From: Al Mitchell amitchell@phius.org
Subject: Re: PHIUS Non-Res Loads, Schedules ?
Date: September 28, 2021 at 10:25 AM
To: Ed May ed@bldgtyp.com

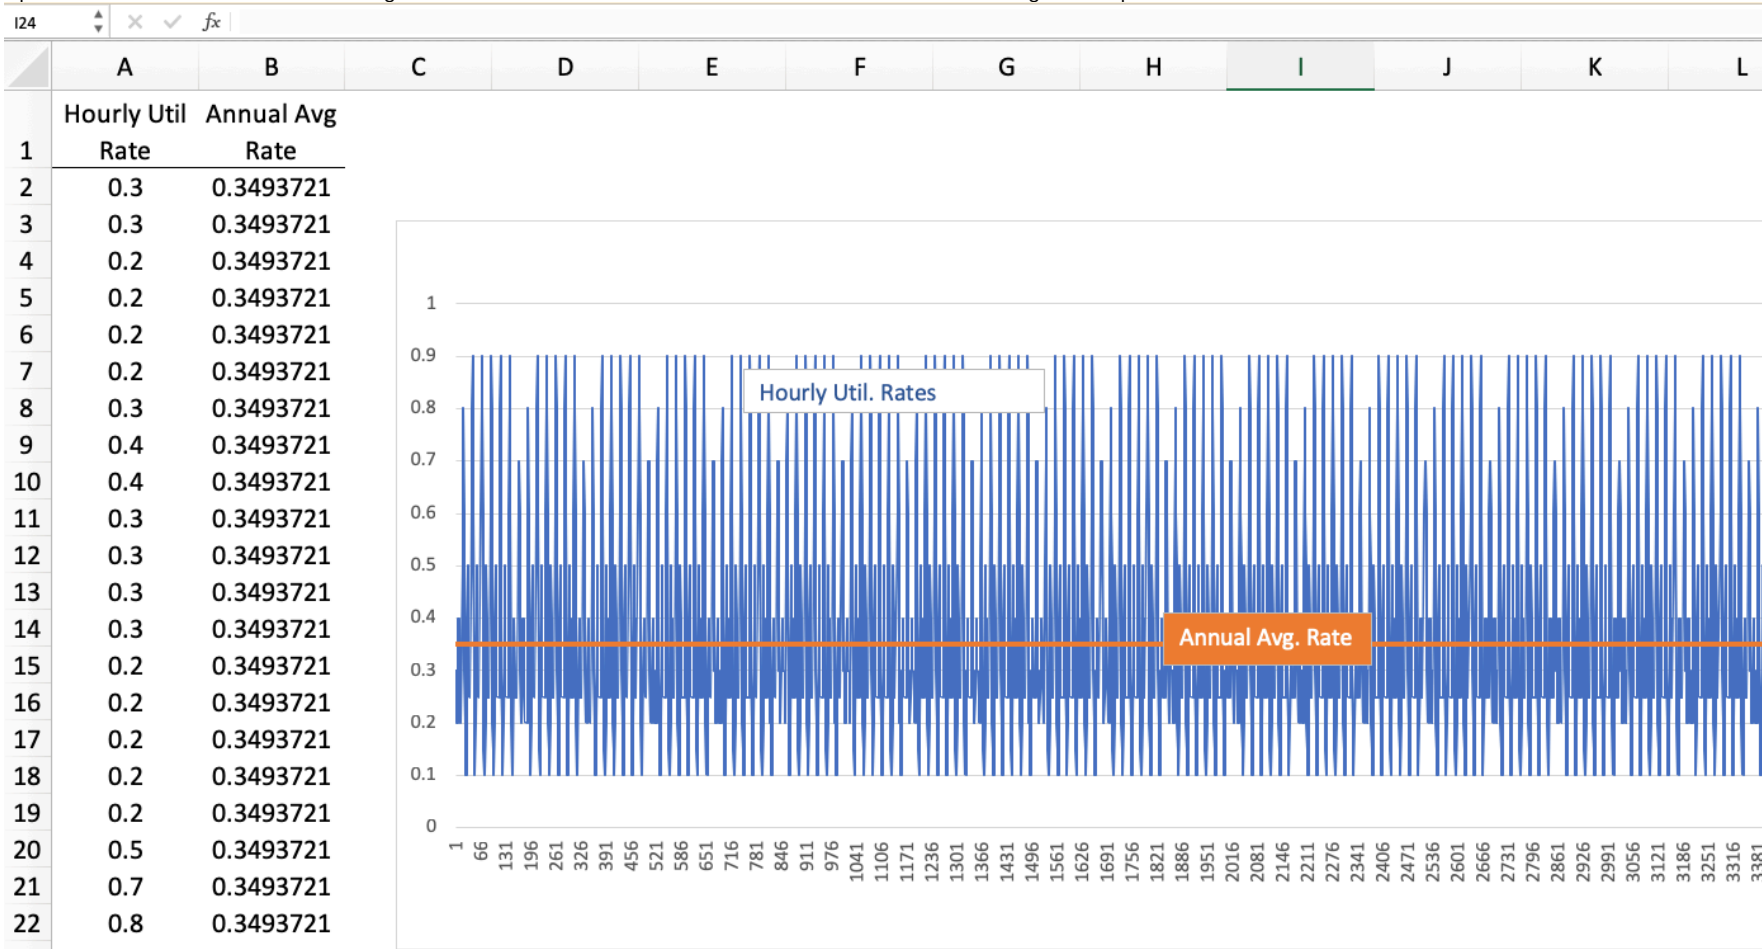
These are loads, not schedules?
Odd that these are here.

1. Doing this will result in more Utilization Patterns. We'd have three for each space type (well, 4 if you include the Ventilation Schedule for the space type as well...). Which is nice from a customization / control / accuracy perspective. But I wonder if you see a downside from this? Obviously more patterns means more to check and verify. But I actually think splitting apart the schedules in this manner probably makes it easier (I hope?) to check / adjust the various bits, as opposed to now where the schedules are all sort of joined together and there isn't clear separation between them?

2. The OpenStudio schedules and loads are all hourly. So they don't map to the 'start hour', 'end hour' WUFI thing very well. So my thought is that we can just set the start / end to 0 and 24 respectively, and 365 days, then calc the annual util factor based on the OpenStudio hourly values, and input that as the use-factor (or absence factor).

Do you think you see any significant issues with entering data this way? The start/end hours aren't important, other than for helping to define the use-pattern, are they? Do you think the reviewers will be unhappy if we don't include those somehow? Personally, I think just entering an annual factor makes a lot more sense than entering a factor of the use-period, as defined by start/end? But if you think those values are super important, then I can rethink that?

Currently I am the only person who reviews non-res projects, so I am not too afraid of reviewing this. I wonder if we could simplify it a bit though, with one pattern for the space covering occupancy, and then use the utilization full hours, EFLH in LEED speak, to cover the electrical and lighting loads.

One of the bigger issues in reviewing this kind of stuff anyways is just confirming where the inputs people put in there are coming from. Many CPHCs are not energy modelers outside WUFI, so coming up with the schedule is a little complicated for them. If people are unsure I have been referring them to COMNET schedules, because they are free, easy to use, and have EFLH calculated. (we have also used these to estimate demand controlled ventilation). These utilization patterns used to apply to calculating PHIUS+2018 non res targets via an external calculator, but this has been replaced in the 2021 calculator.
